Planning Officer: Harry Chalk
Planning Application Ref: WA/115/21/T
Location: Oak Bank, Wandleys Lane, Walberton, BN18 0QR
Description of works: Various work to 1no. oak tree (T1)
Reasons given: 1. Reduce risk of branch failure 2. Improve sightlines

Comments on Application:

Figure 3 Crown lifting

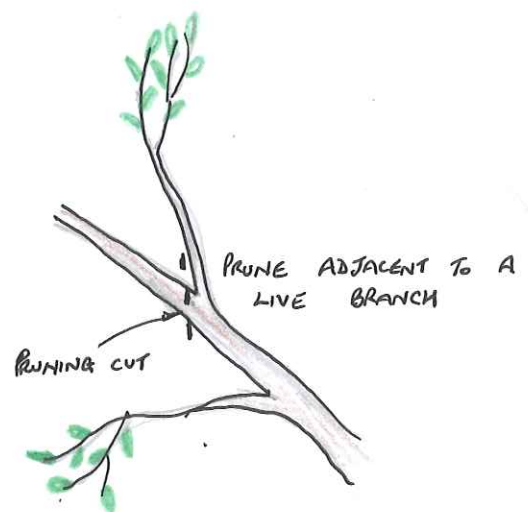
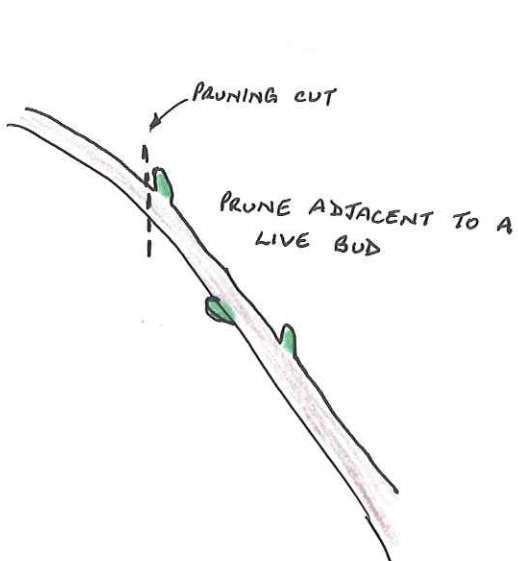
- Low branches from the oak (T1) may affect broader enjoyment/use of the property in future.
- The proposal to raise the crown to provide 5metres overhead clearance on all aspects is potentially harmful to the trees ongoing vitality and exceeds British Standard (BS3998:2010) Tree work – Recommendations.

'Crown lift (removal/reduction of low branches) to achieve a maximum of 4metres overhead clearance on all aspects and only where pruning wound size does not exceed 75mm diameter.'

Figure 2 Positions of final cuts

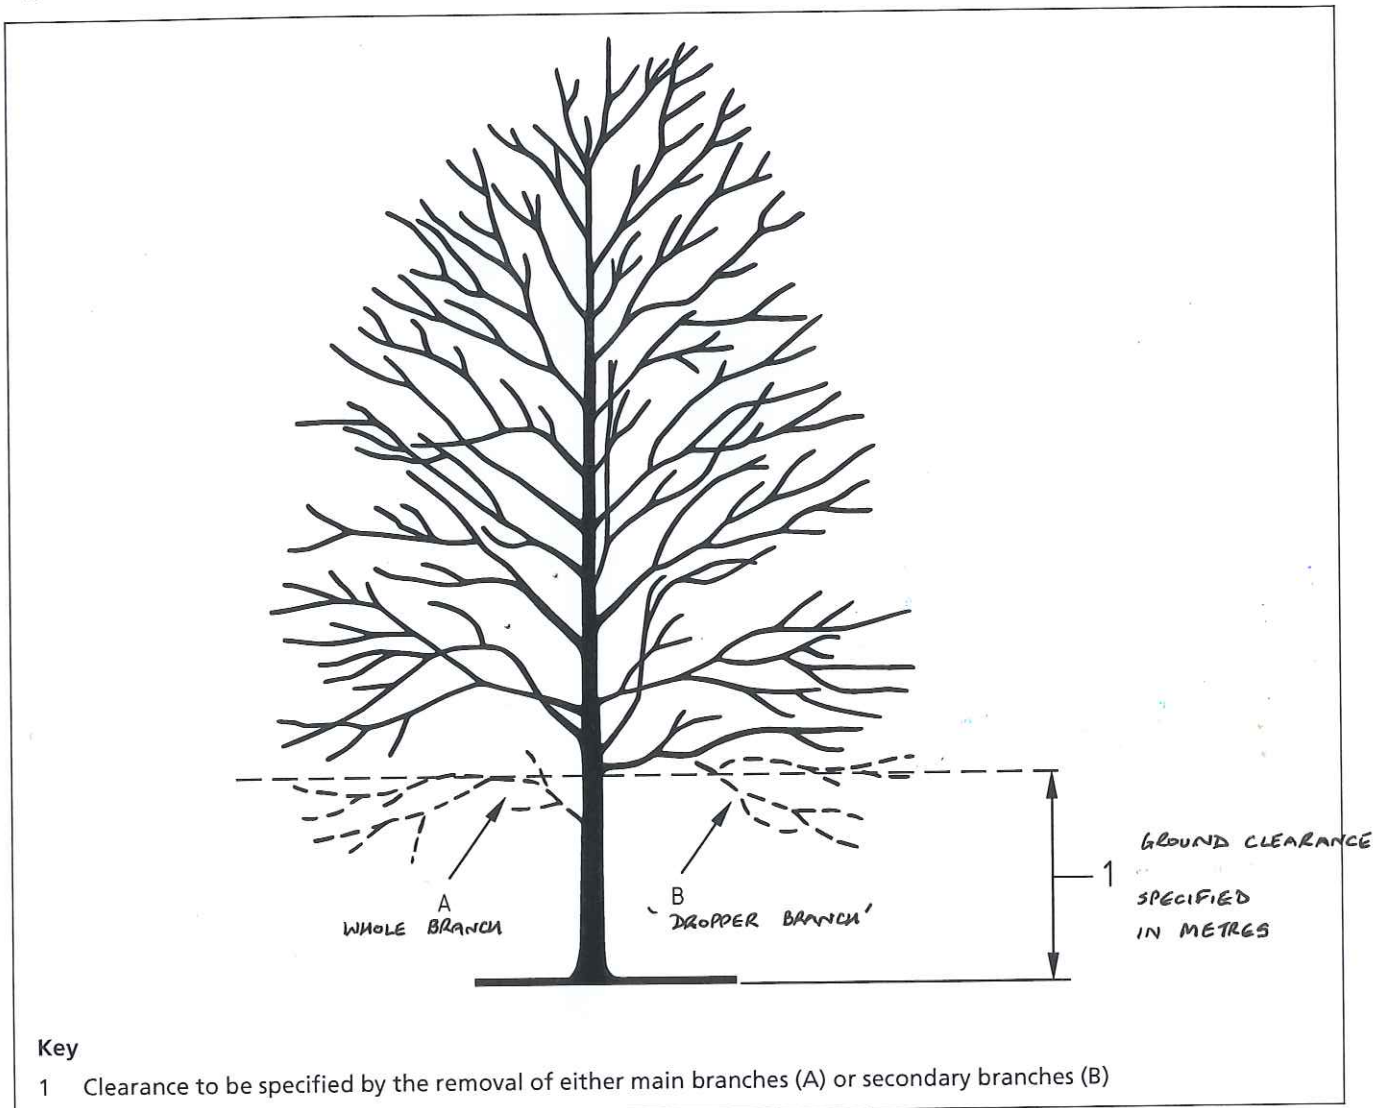
Part a) Where whole branches are to be removed and final cuts made close to the trunk or branch union they are to be made as shown in Figure 2 of BS3998:2010
